Model: Model J-C1		Date: 26-Jan-04	No.: RB149001
Subject: Firmware Release History (Engine)		Prepared by: H. Someya	
From: 1st Tech. Support Sec. Service Support Dept.			
Classification:	<input type="checkbox"/> Troubleshooting <input type="checkbox"/> Part information <input type="checkbox"/> Action required <input type="checkbox"/> Mechanical <input type="checkbox"/> Electrical <input type="checkbox"/> Service manual revision <input type="checkbox"/> Paper path <input type="checkbox"/> Transmit/receive <input type="checkbox"/> Retrofit information <input checked="" type="checkbox"/> Other ()

Model: Model J-C1		Date: 26-Jan-04	No.: RB149002
Subject: Service Manual Correction		Prepared by: H. Someya	
From: 1st Tech. Support Sec. Service Support Dept.			
Classification:	<input type="checkbox"/> Troubleshooting <input type="checkbox"/> Part information <input type="checkbox"/> Action required <input type="checkbox"/> Mechanical <input type="checkbox"/> Electrical <input checked="" type="checkbox"/> Service manual revision <input type="checkbox"/> Paper path <input type="checkbox"/> Transmit/receive <input type="checkbox"/> Retrofit information <input type="checkbox"/> Other ()

Mode

6. Replace the 7 Mylars shown in the photo (red circles).

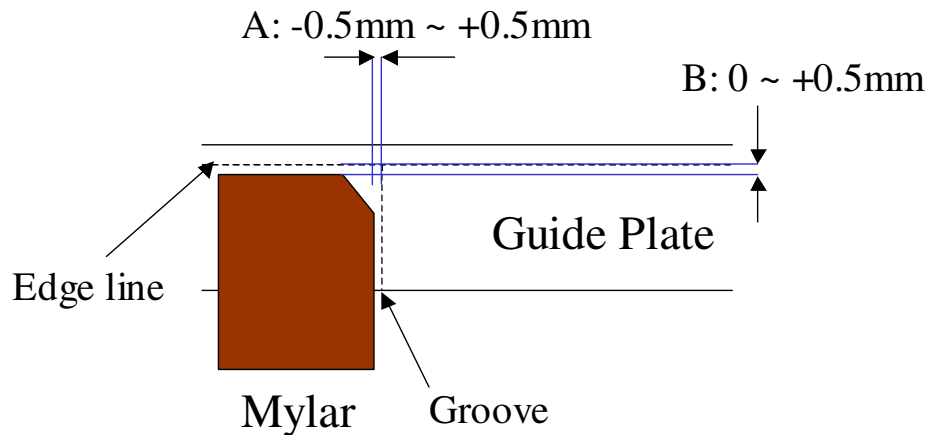
Replace the seven Mylars shown below (P/N G3484682, Sheet: Gate: 2).

- Refer to the **Attachment Specifications** below.
- Clean the attachment area for each Mylar before you attach the new one.
- Press hard on the attachment area of the Mylar.
- Make sure the Mylar is not sticking out from the guide plate.

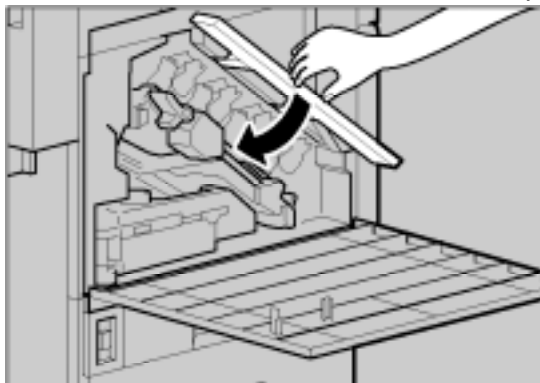
The drum plate can bend if development unit K (Y) is not set correctly. This will not let development unit C (M) get set correctly. At this time, development unit C (M) cannot mesh with the mainframe drive gear. As a result, the development unit cannot be driven when the main switch is turned on.

Do these steps before you turn on the main switch.

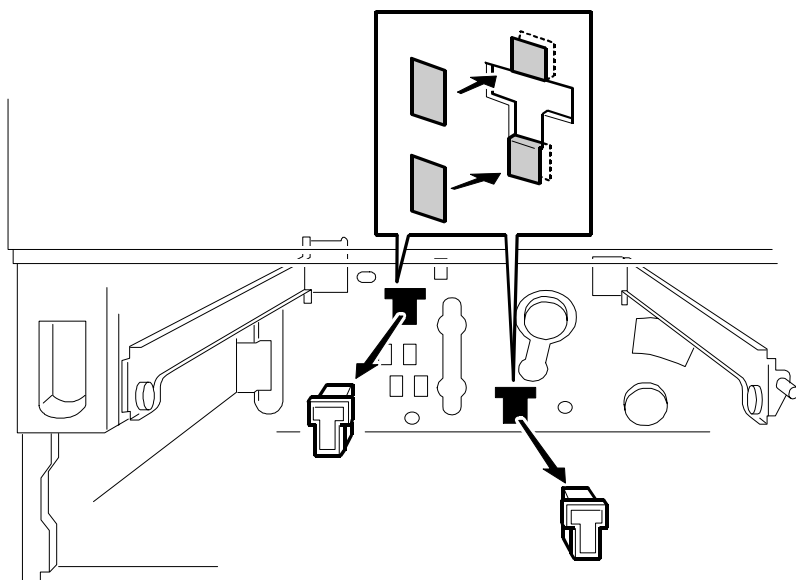
Use this procedure to attach the tape (G0123897 X 4).

1. Remove the rear cover
2. Remove the high voltage supply unit
3. Remove the sub power supply unit
4. Remove the tray holder
5. Attach the tape according to the following picture
6. Reassemble the machine

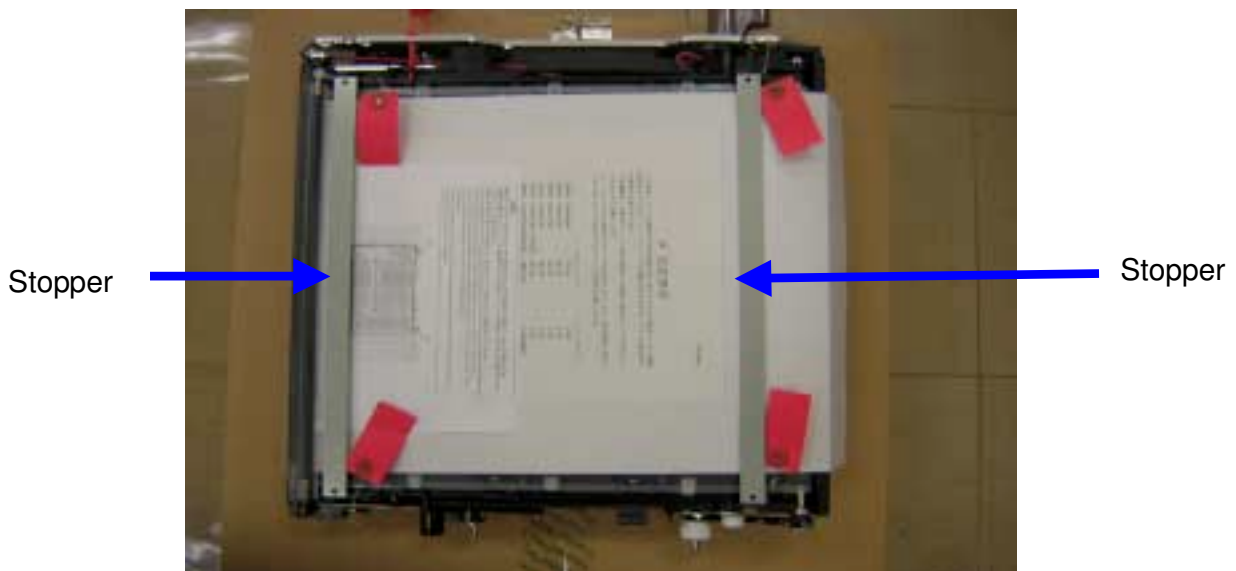
Vibration during transport makes the springs come loose.

Two stoppers were added to the unit (see the photo below).

- Remove the two stoppers before you install the new transfer unit.
 - Remove the wires at the four ends of the stoppers
 - Remove the four red tags

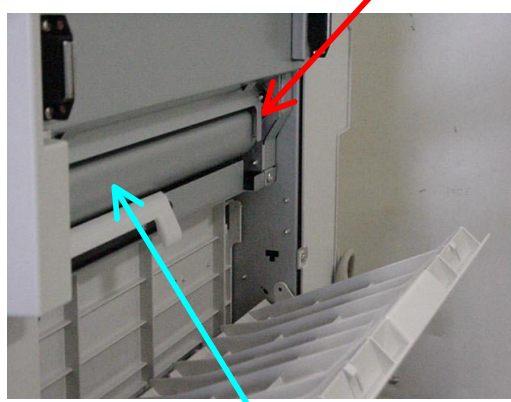
When the engineer removes the shipping tape at installation, he/she pushes the grounding plate **[A]** and bends it by mistake **[B]**. As a result, this interferes with the movement of the guide plate **[C]**.

- At machine installation:**
Do not press **[B]** the grounding plate when you remove the shipping tape.
- If the symptom occurs in the field:**
 - Check the grounding plate to see if it is bent.
 - If the plate is bent:
 - Bend it back as follows:
 - Direction: Away from the paper path
 - Amount: Target **2-3mm** (max. 5mm)

- Replace the grounding plate.

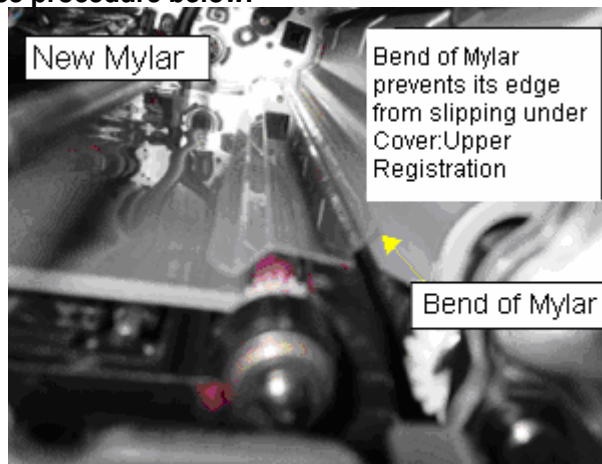
Replace the guide Mylar at the entrance of the transfer unit with P/N **B1803908**.

Note: This new guide Mylar is bent, which prevents the edge of the guide Mylar from slipping under the Cover: Upper Registration.
